APPLICATION FOR PERMISSION UNDER SECTION 16 OF THE TOWN PLANNING ORDINANCE (CAP.131)

(a) Proposed use(s)/development 擬議用途/發展	Proposed Temporary Warehouse for Storage of Construction Materials (Timber and Metal) (Please illustrate the details of the proposal on a layout plan) (請用平面圖說明擬議詳情)

Date: 17 February 2023
Your Ref.: TPB/A/YL-KTS/946
Our Ref.: LDS/PLAN/6859

Table 1: Responses to Comments from Government Department on Planning Application No. A/YL-KTS/946 (17 February, 2023)

Figure 1 : Swept Path Analysis

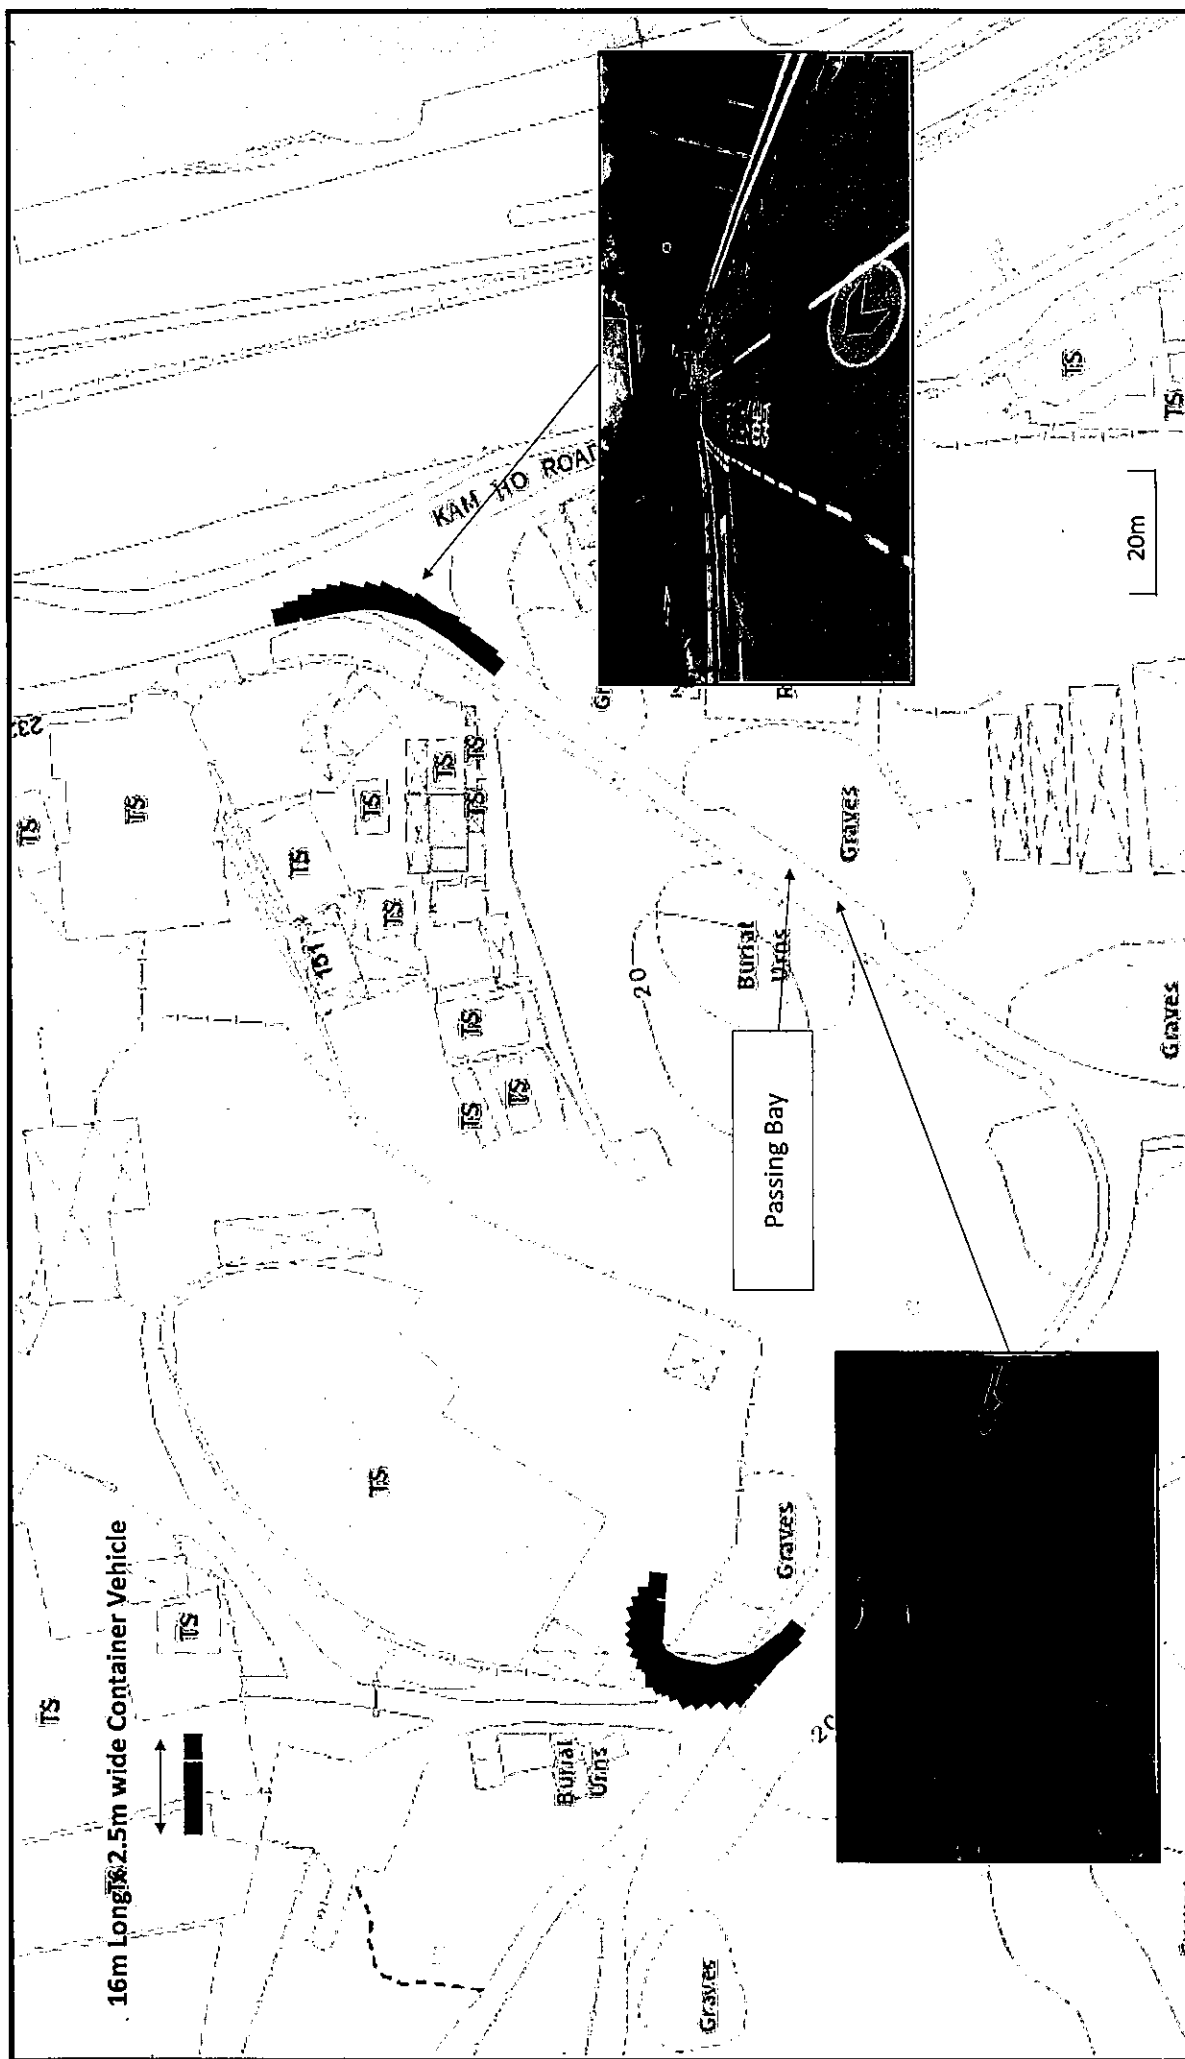
(b) The applicant should demonstrate the smooth manoeuvring of vehicles to /from Kam Ho Road, and along the local access to the site;	(b) The Figure 1 , the swept path analysis shows that the swept path from Local Access Road to Kam Ho Road and to the application site are adequate.

Section drawing of window opening for the structure (2)

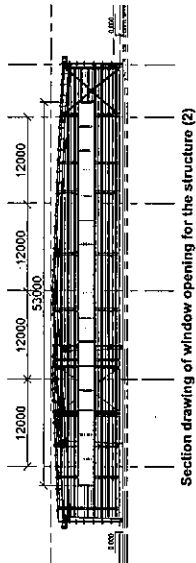
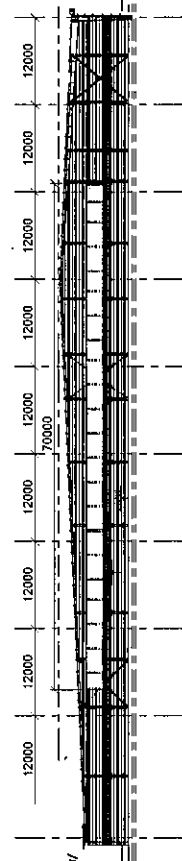
COMMENTS	RESPONSES
2. Fire Services Department	
Please find the following comments on the submitted FSIs proposal:	
(a) Please clarify the length of the proposed openable windows for Structure 2, whether it is 53m as stated in the calculation or 55m as delineated in the section drawing;	(a) The length of the proposed openable windows for Structure 2 is 53m. Please refer to the revised FSIs proposal in Annex 1 .

ANNEX 2

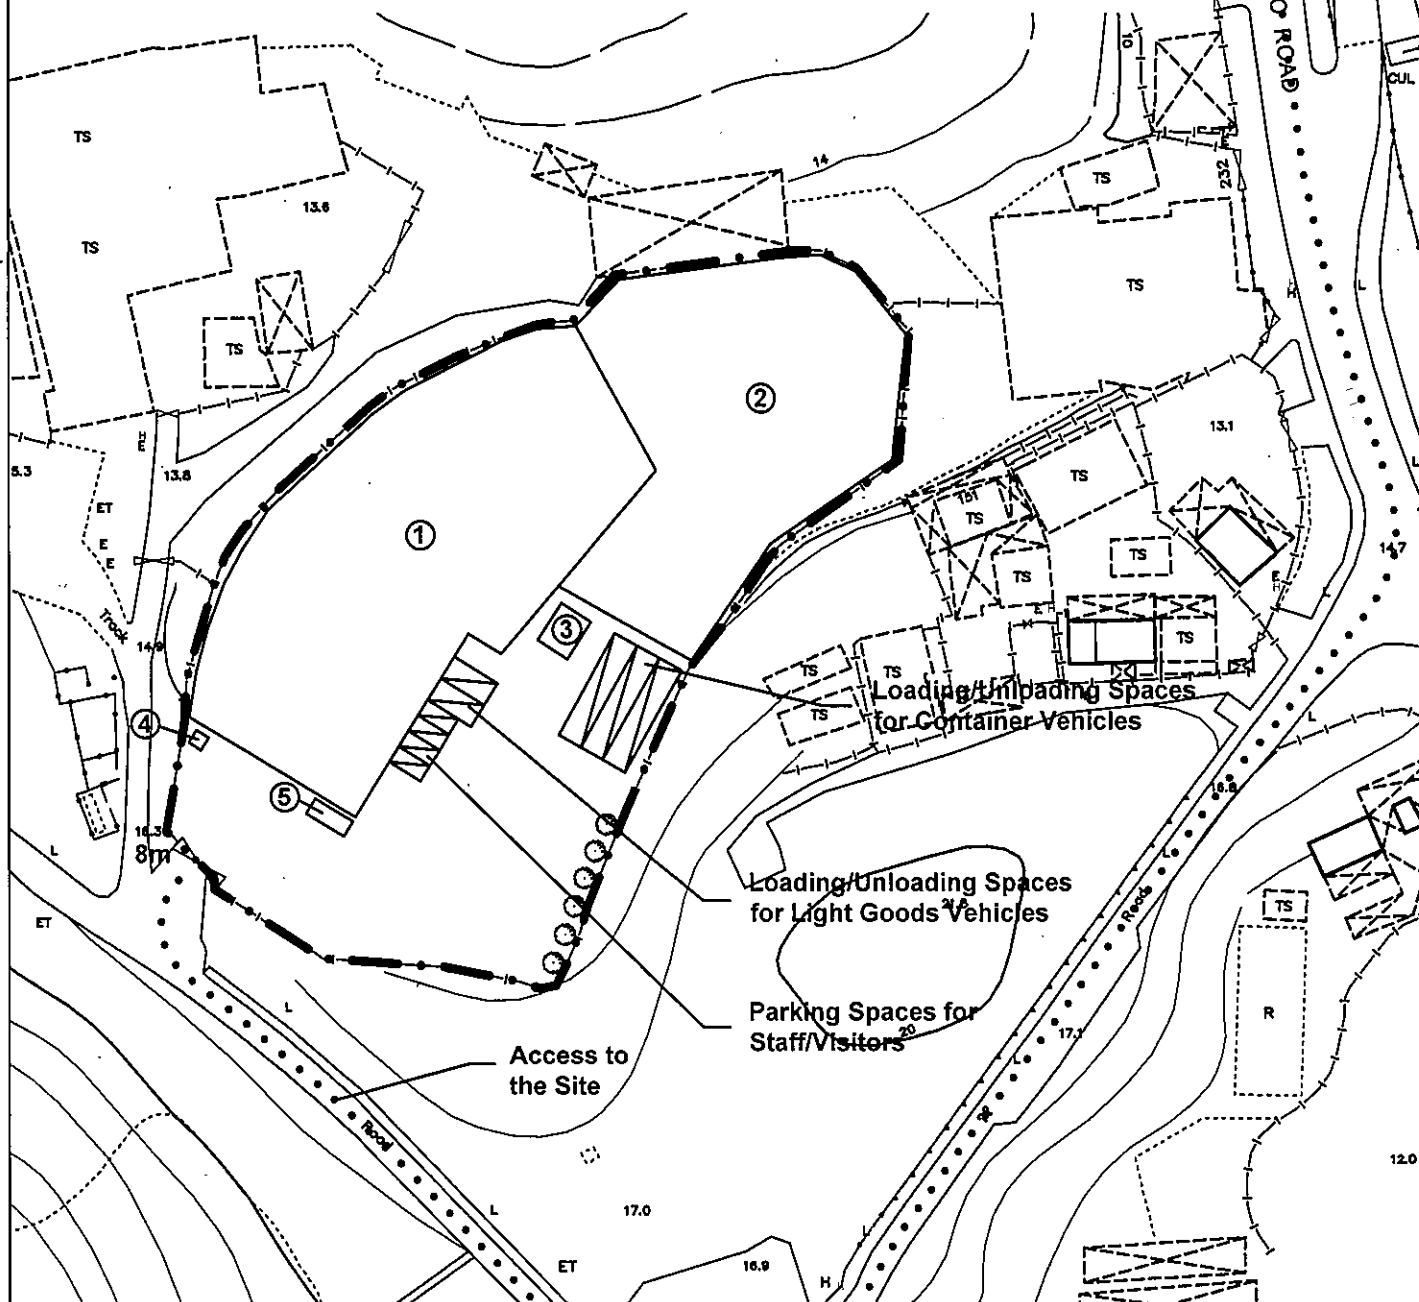
2.	Urban Design and Landscape Section, Planning Department Having reviewed the Further Information (FI), please find following comments from landscape planning perspective: (a) the applicant claimed in the FI that there are no existing trees within the application site. According to our site inspection taken in January 2023, some existing trees of common species are observed within the site and may be in conflict with the proposed structure 2 and site office. No tree information, proposed tree treatment and mitigation measures (if any) are provided in this FI; and (b) we remain our view of having some reservations on the application.	(a) According to our site visit in March 2023, only 2 existing trees (see Photo 1 in Annex 2) within the Application Site will be affected by the proposed structure 2. These trees of common species are proposed to be felled. It is proposed that 6 new trees will be planted along the eastern boundary of the site for compensation (see Landscape Proposal in Annex 2). The proposed tree species is Ficus Microcarpa, which grow to a mature height of 4 to 5 metres, with a canopy span of about 5 metres in diameter. The proposed tree height is 2.75 metres when first planted in the ground.

Drawing No. 002

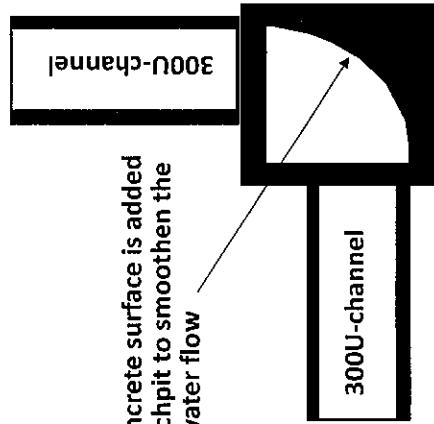
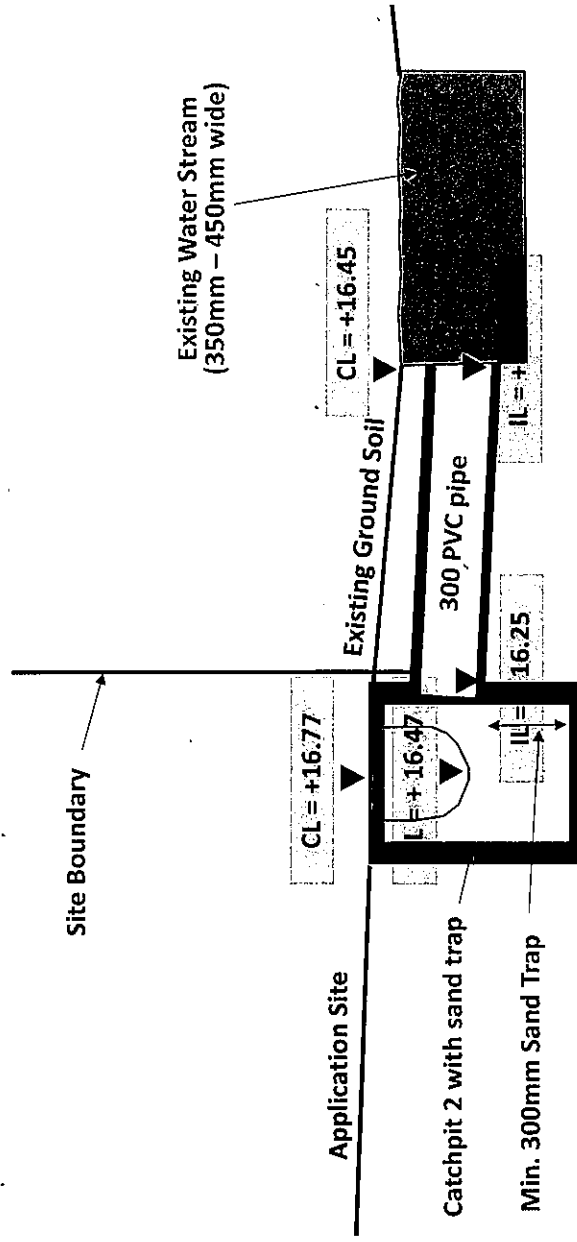
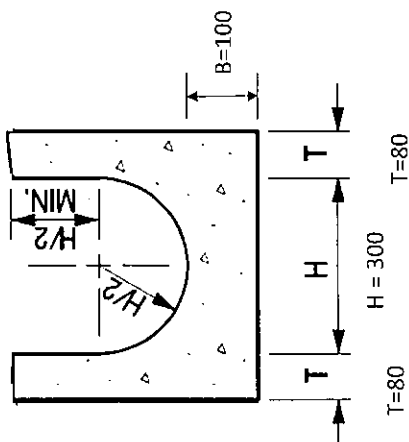
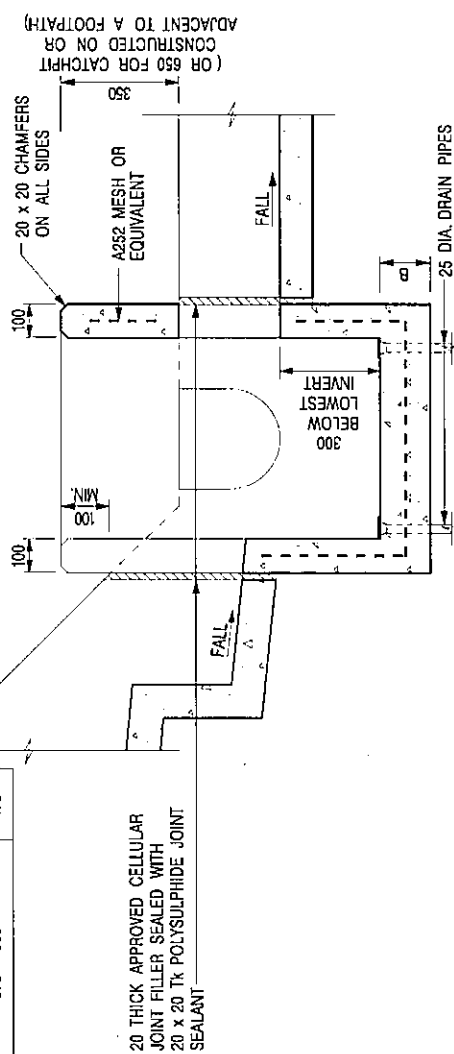
COMMENTS	RESPONSES
3. Drainage Services Department	
Please find the following comments on the submitted drainage proposal:	
(a) Cross sections showing the existing and proposed ground levels of the captioned site with respect to the adjacent areas should be given.	(a) Topographic survey on the Application Site and surrounding areas has been carried out and is shown on Drawing No. 001 – Drainage Plan and the cross-section details is shown on Drawing No. 002 – Catchpit details (see Annex 3).

(h) Standard details should be provided to indicate the sectional details of the proposed u-channel and the catchpit/sand trap.	(h) Drawing No. 003 – Typical Details for Catchpit and U-channel has shown the details.

Figure 1 - Chart for the rapid design of U-shaped and half-round channels up to 600 mm

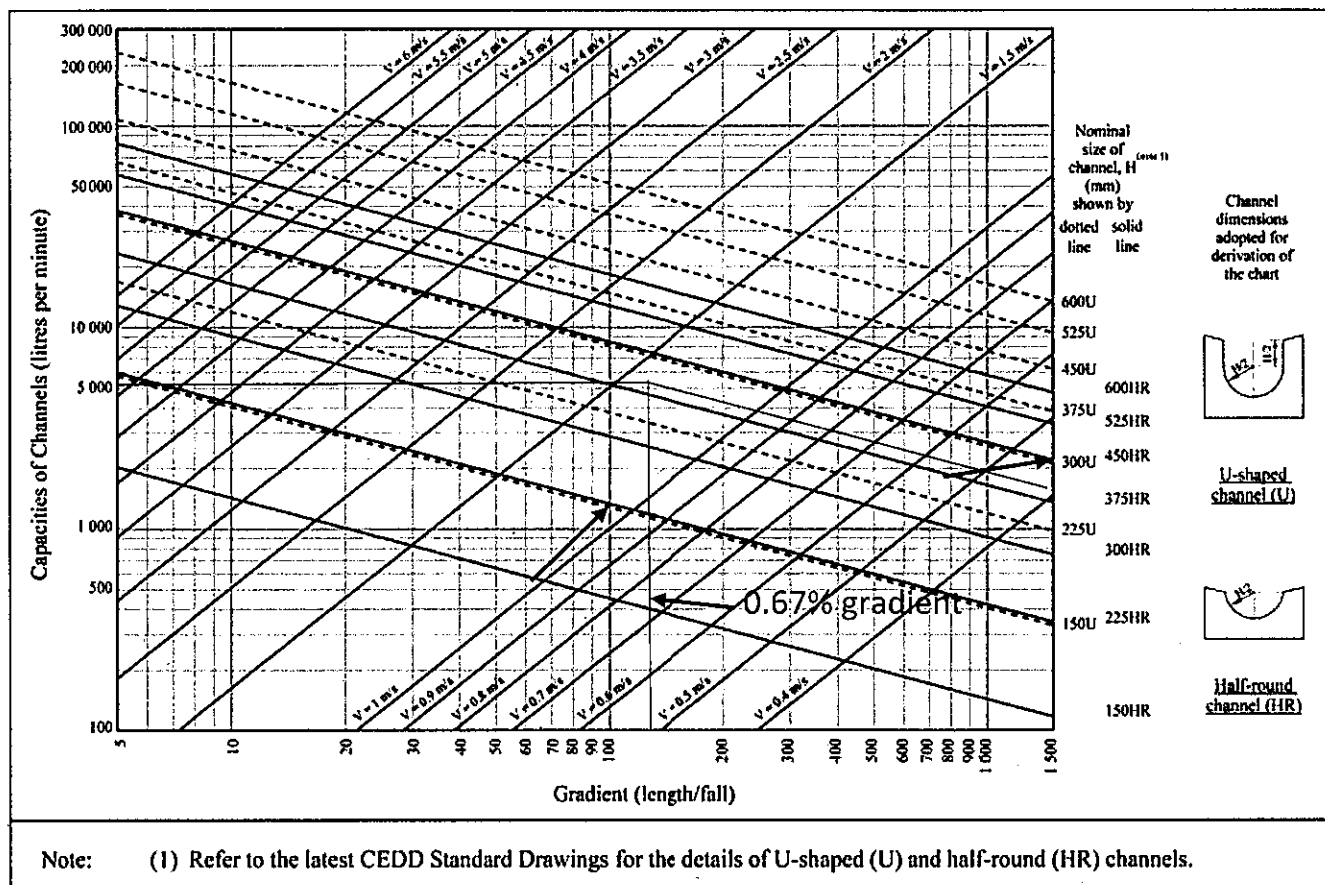
(c) Please also demonstrate with hydraulic calculation that the existing drainage facilities are adequate to collect, convey and discharge the surface runoff accrued on the application site and the overland flow intercepted from the adjacent lands.	(c) Drainage Design and calculation is enclosed for your comment and approval.

For 5,214 l/min, 300 U-channel is used.

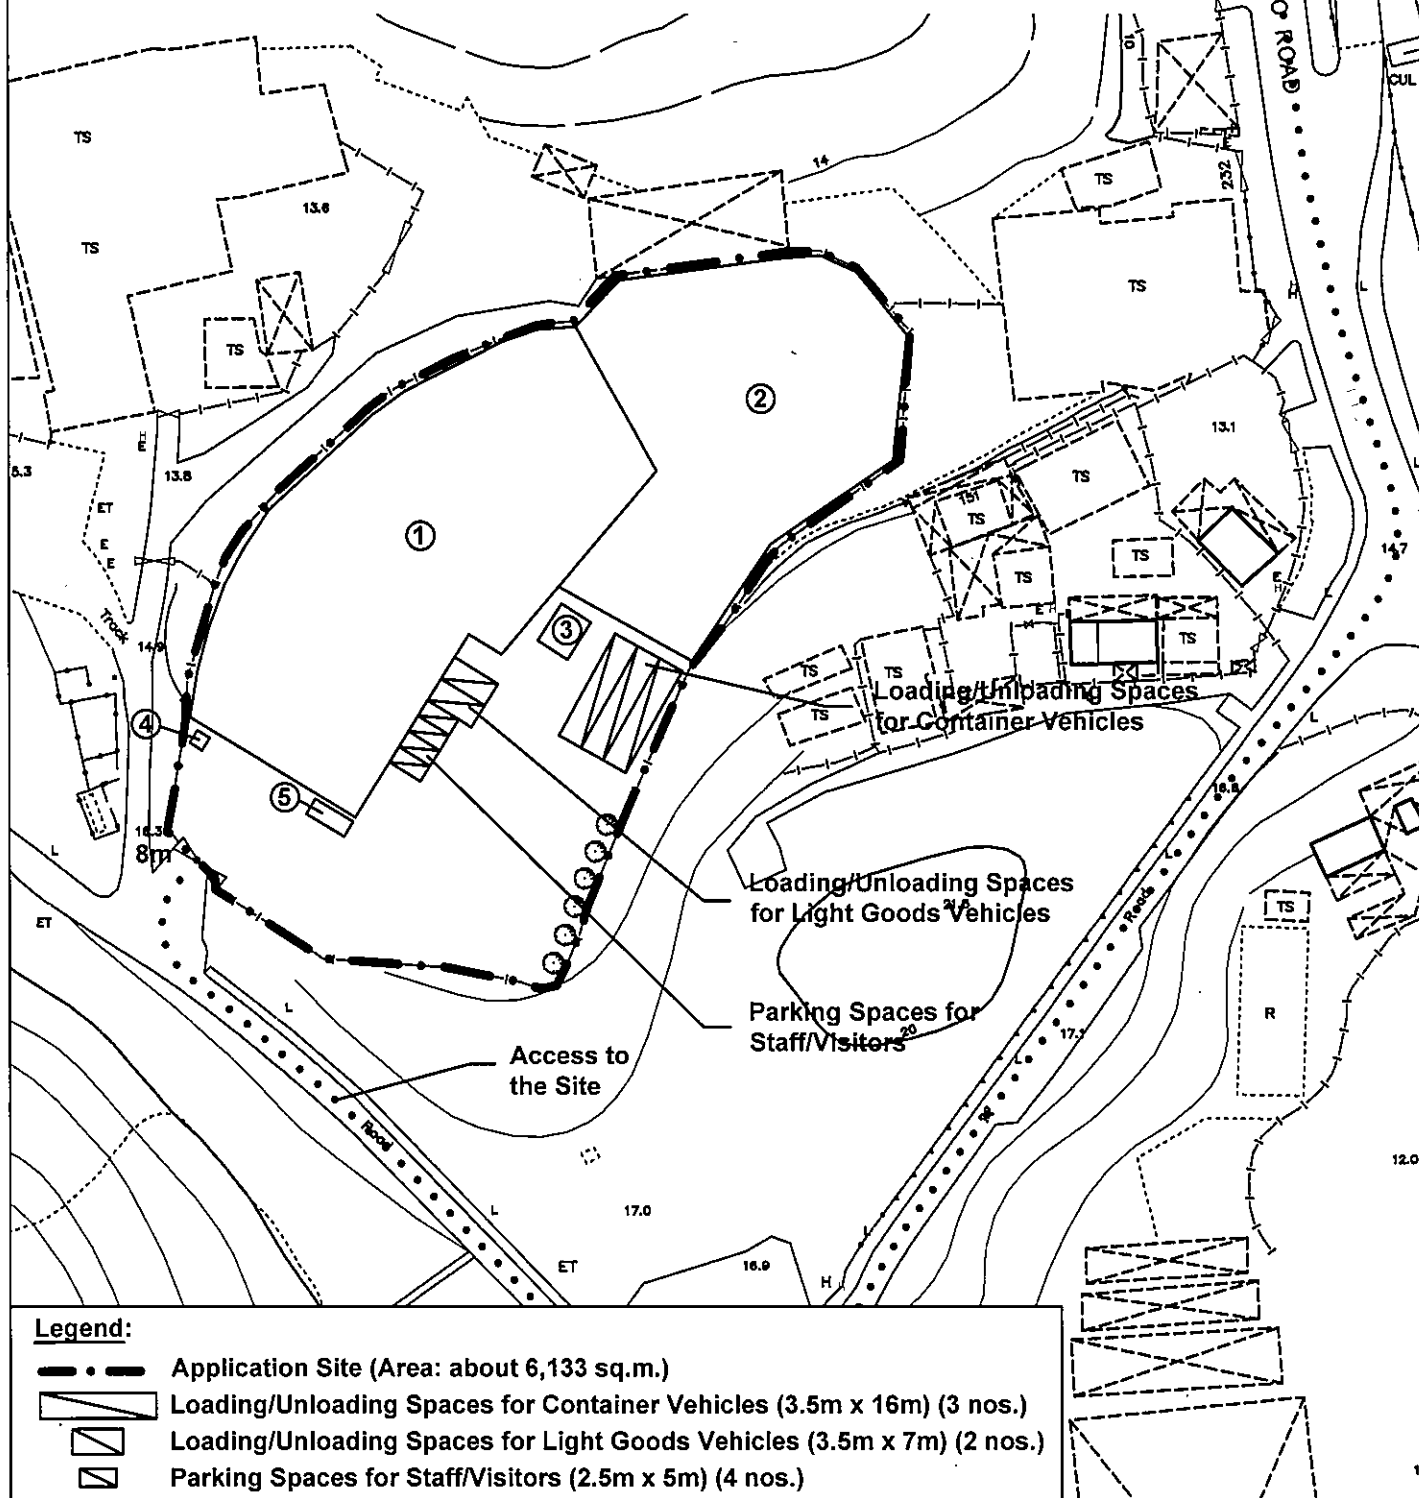
(c) <u>Detailed/Advisory Comments:</u> It is noted that 6 nos. of <i>Ficus microcarpa</i> are proposed as compensation. Considering mature <i>Ficus</i> is large in tree size, the applicant is advised to propose alternative species for new tree planting.	(c) The Applicant proposes to plant <i>Bauhinia blakeana</i> (see the revised Landscape Proposal in Figure 5A). The Applicant will submit a Landscape Proposal to the satisfaction of the Planning Department in detailed design stage, if necessary.

Section drawing of window opening for the structure (1)

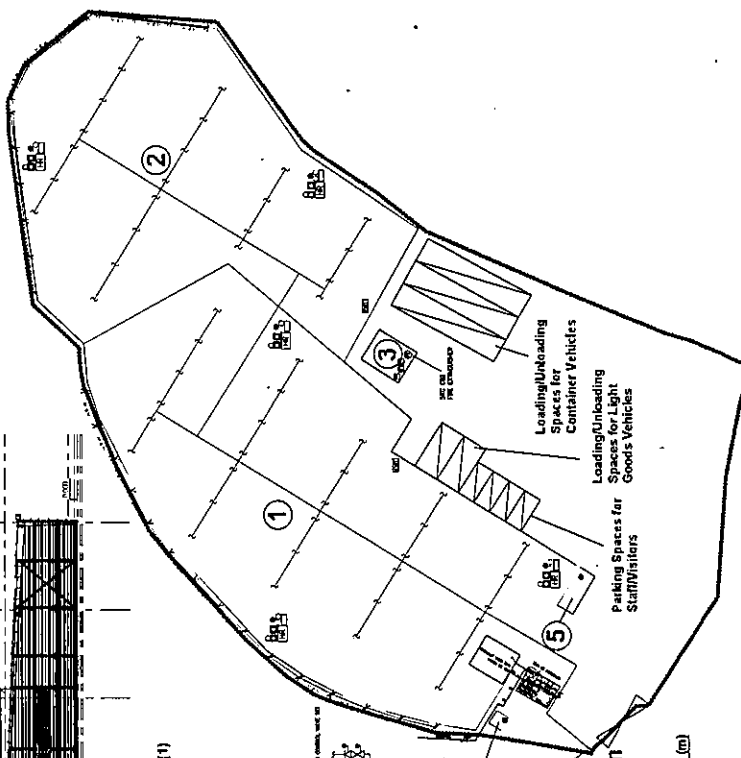
(b)	The height of openable windows shall be indicated on the Section Drawing.	(b) The height of openable windows has been indicated on the Section Drawing.
